Re: Third Submission Review – Kum & Go C-Store – Site Plan, Conditional Uses, & Replat
Application Number: **DA-1670-04**
Case Numbers: **2020-6053-00, 2020-6053-01, 2020-6053-02, 2020-3051-00**

Third Submission Review

KUM & GO GAS AND C-STORE AT POMEROY SITE PLAN
WITH CONDITIONAL USE
A RESUBDIVISION OF OF LOT 1, BLOCK 2 OF POMEROY SUB. FLG. NO. 1 BEING
PART OF THE SOUTH HALF OF SECTION 16, TOWNSHIP 5 SOUTH, RANGE 66
WEST OF THE 6TH P.M., CITY OF AURORA, COUNTY OF ARAPAHOE, STATE OF
COLORADO

1

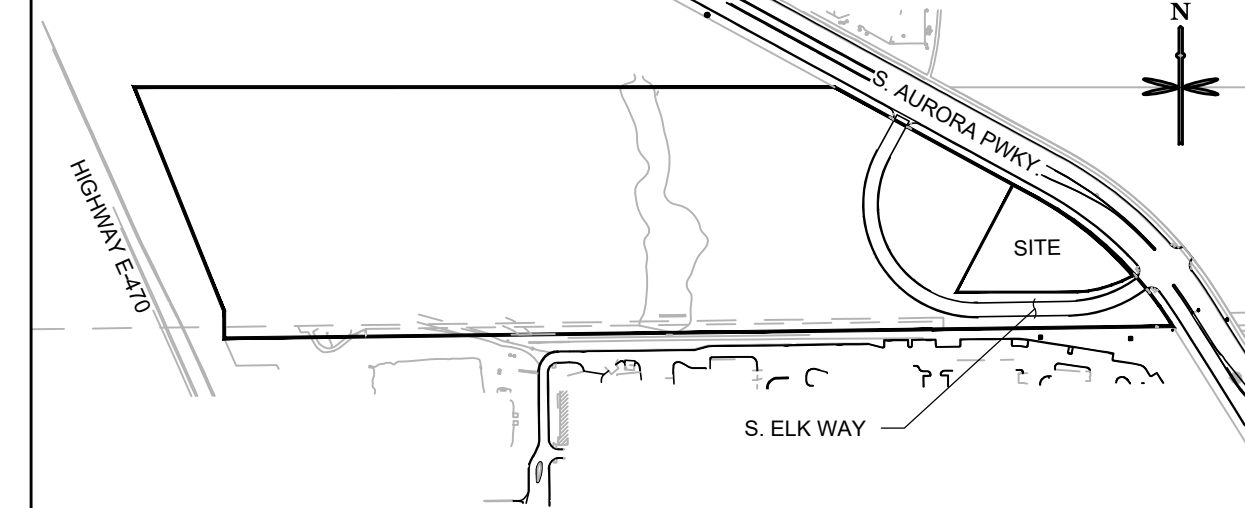
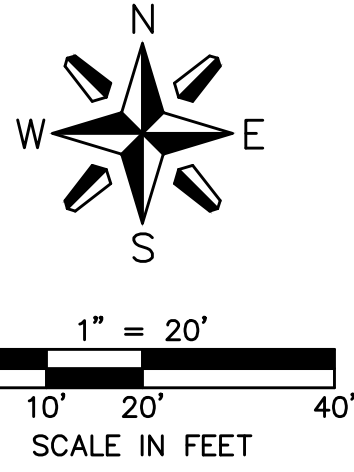
4A. The site plan will not be approved by Public Works until the preliminary drainage letter/report is approved.

The site plan will not be approved by public works until the preliminary drainage letter/report is approved

EES Response: Acknowledged

EES Response:
Acknowledged

SITE PLAN

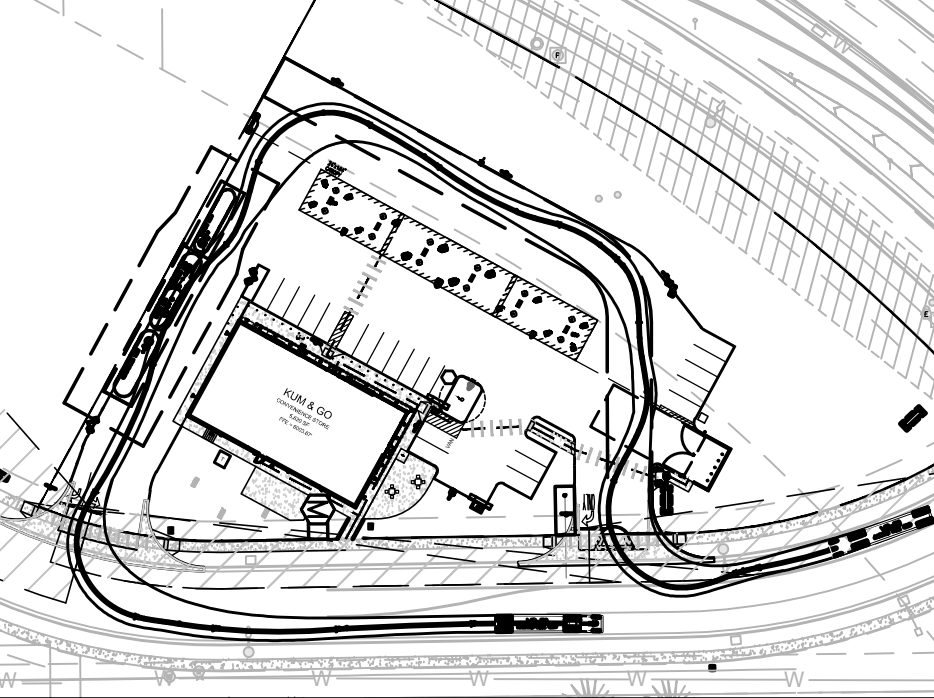
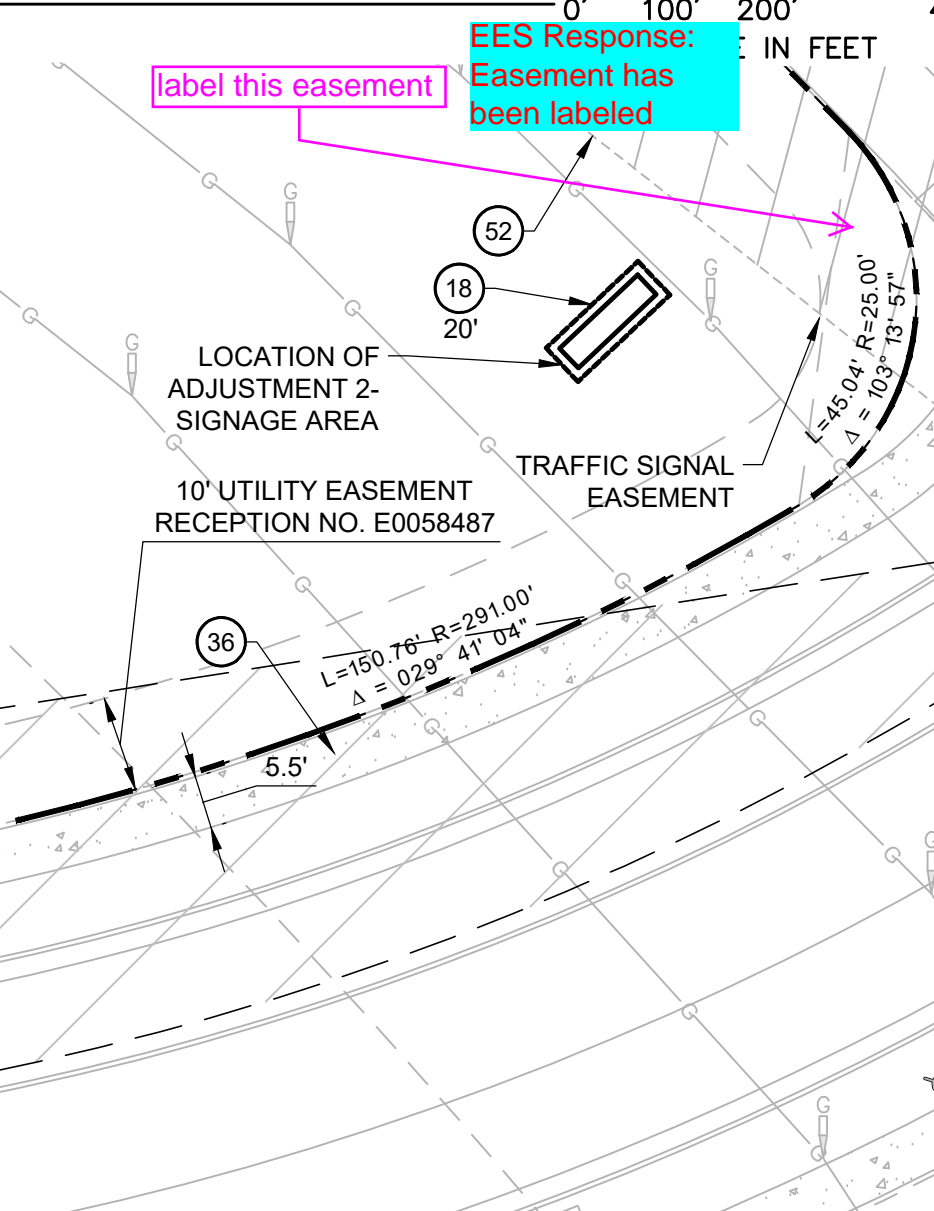
6A. Verify that the fire lane & public access easement label match on site plan and plat.

6B. Relocate the light pole and fire lane sign so they do not encroach into the fire lane easement.

6C. Adjust fire hydrant so outlets face the street.

EES Response: Fire Lane & Public Access easement now match on site plan and plat.

EES Response: Light pole location has been adjusted.

EES Response: Fire hydrant has been removed per discussion with Mark Apodaca.

UTILITY PLAN

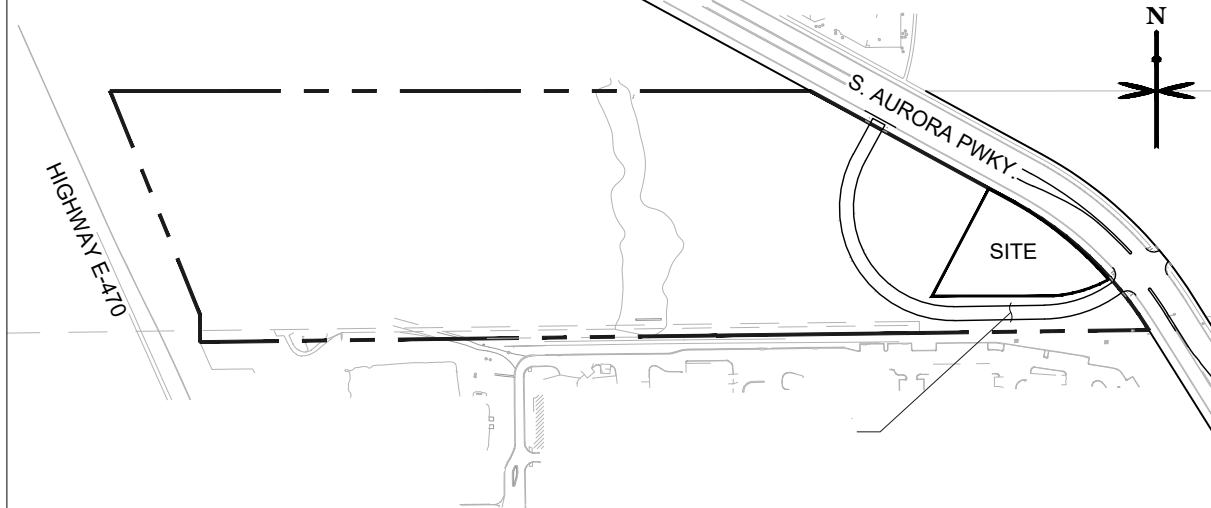
8A. Include required water meter size. Please follow format as listed in section 5 of Aurora Water specifications

8B. Indicate size and type of material for water service line

8C. To be in drainage easement

EES Response: Meter size has been provided.

EES Response: Material type and size have been provided.

EES Response: Per discussion with Nina Khanzadeh, this comment can be disregarded.

1 LANDSCAPE PLAN

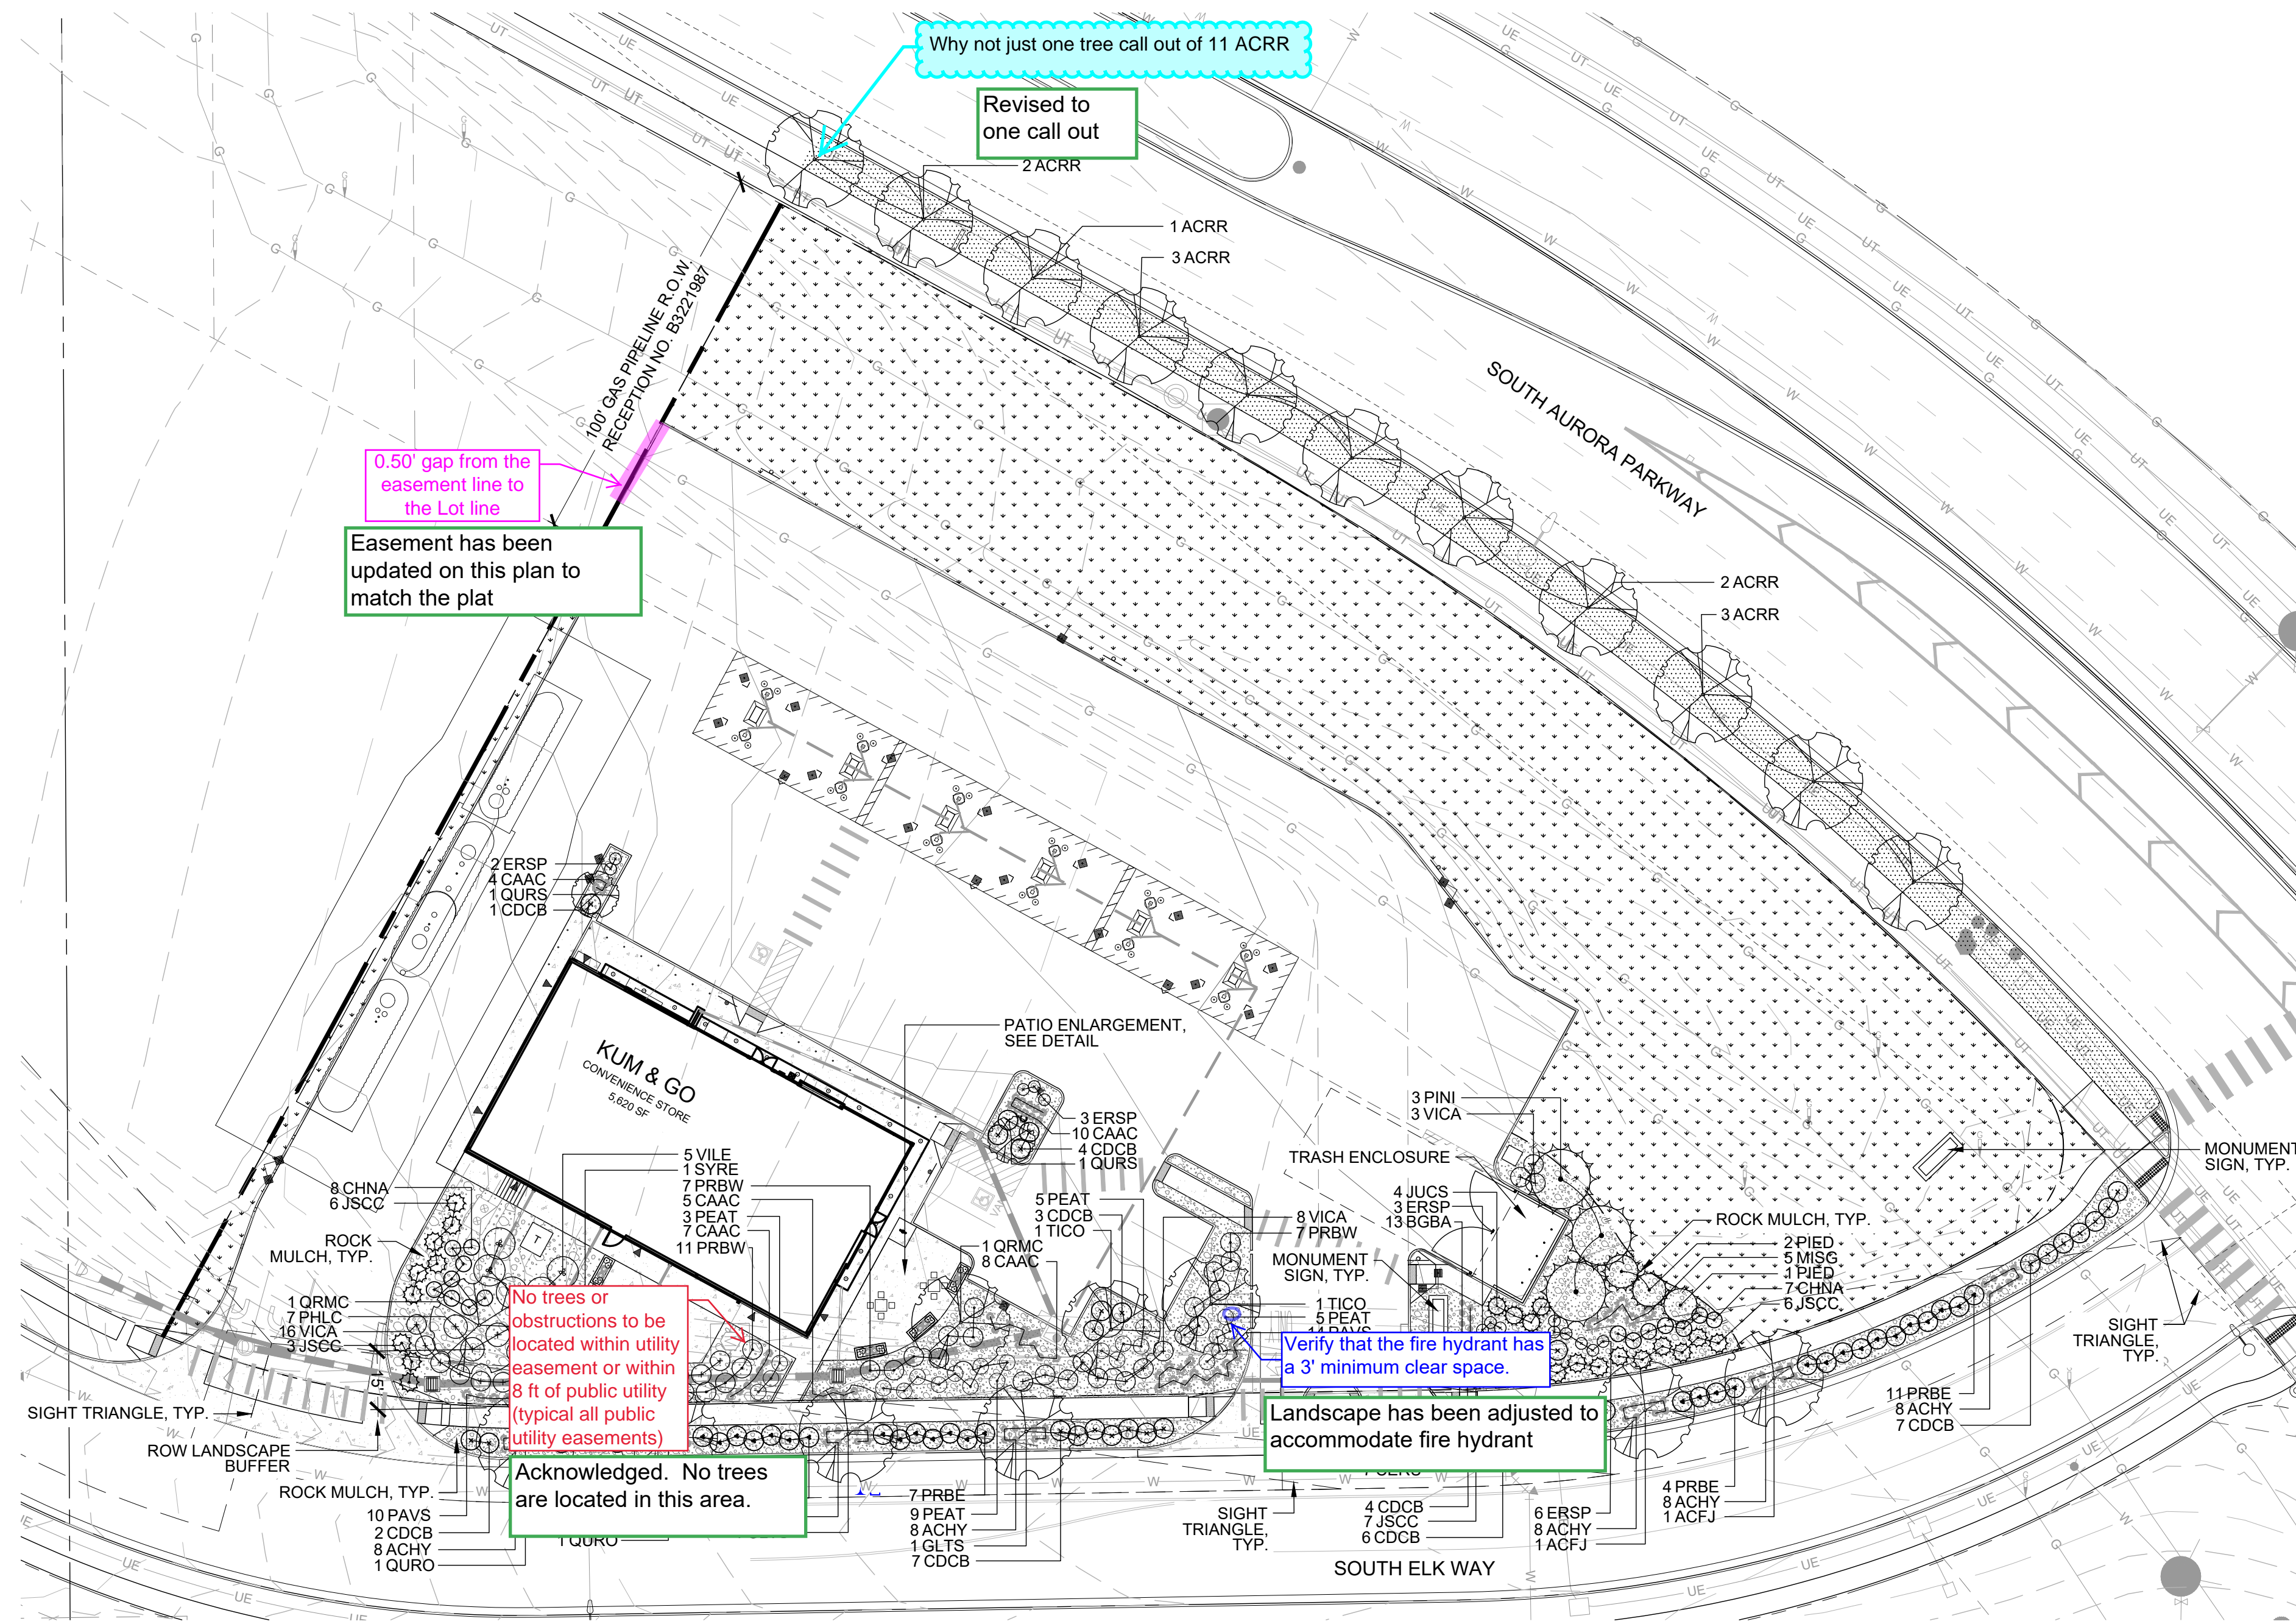
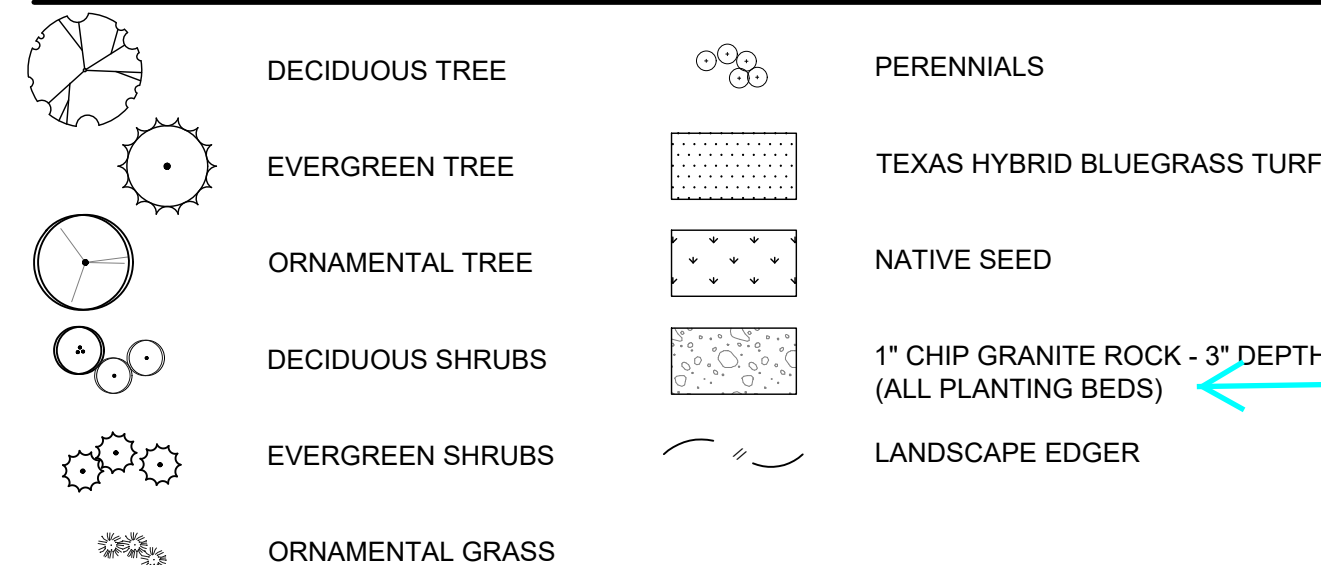
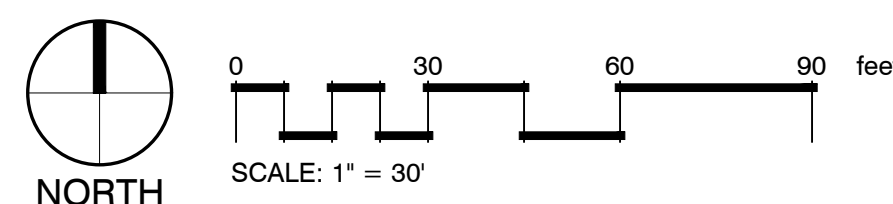
3A. Why not just one tree call out of 11 ACRR

3B. Grasses may be used in the curbside landscape, but they have to be 5 gallon and they can not be more than 40% of the total plant count or 28 total at 5 gallon. 4C.

3D. 105 shrubs

3E. Because this is being used in all landscape beds, do not use a hatch and just handle the mulch type with a note. The hatching makes the landscaping within the beds more difficult to see/read

3F. 83 shrubs

6D. Verify that the fire hydrant has a 3' minimum clear space.

8D. No trees or obstructions to be located within utility easement or within 8 ft of public utility (typical all public utility easements)

Grasses may be used in the curbside landscape, but they have to be 5 gallon and they can not be more than 40% of the total plant count or 28 total at 5 gallon

LANDSCAPE BUFF 105 shrubs

Because this is being used in all landscape beds, do not use a hatch and just handle the mulch type with a note. The hatching makes the landscaping within the beds more difficult to see/read.

Response: Revised to one call out.

Response: Grasses revised to #5 and 24 count in the curbside landscape.

Response: Revised

Response: Hatch has been turned off and mulch call outs have been added.

Response: Revised

Response: Landscape has been adjusted to accommodate fire hydrant.

Response: Acknowledged. No trees are located in this area.

Grasses revised to #5 and 24 count in the curbside landscape.

Hatch has been turned off and mulch call outs have been added
